1.1 ADDENDUM FORM

- .1 This Addendum forms part of the Contract Documents and modifies the Bidding Documents dated 22 May 2018, with amendments and additions noted below.
- .2 Acknowledge receipt of this Addendum in the space provided in the Bid Form. Failure to do so may disqualify the Bidder at the Owner's discretion.
- .3 This addendum consists of one (1) page plus the following:

1 EXTENT OF CHAIR RAIL
 RA-1 SCALE: 1:150

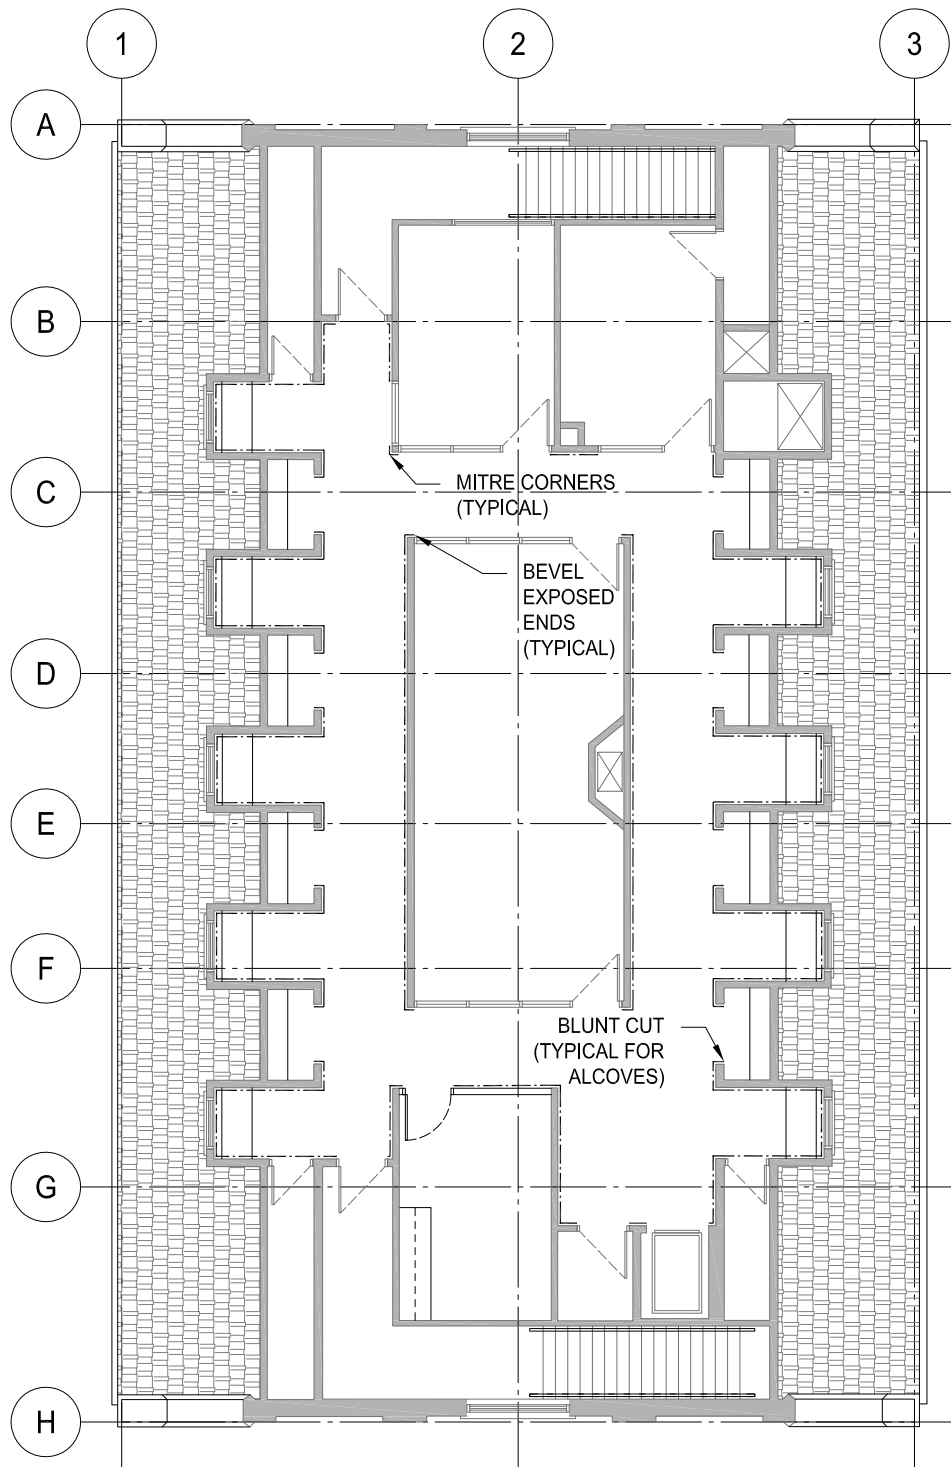
- .1 Drawings - appended to this addendum, to be added to the Project Manual.
 - .1 **ADD** RA-1 Extent of Chair Rail
 - .2 Refer to A3.1, Finishes Notes. **REVISE** Note A to read: All walls and drywall ceilings to be painted. Surface mounted ducting and radiators to be painted to match adjacent surface.
 - .3 Refer to A3.1 Finishes Notes. **REVISE** Note B to read: All doors and hollow metal door/window frames to be painted.
 - .4 Refer to A3.1 Finishes Notes. **ADD** Note D: New chair rail to be painted. Colour to be selected by Consultant.
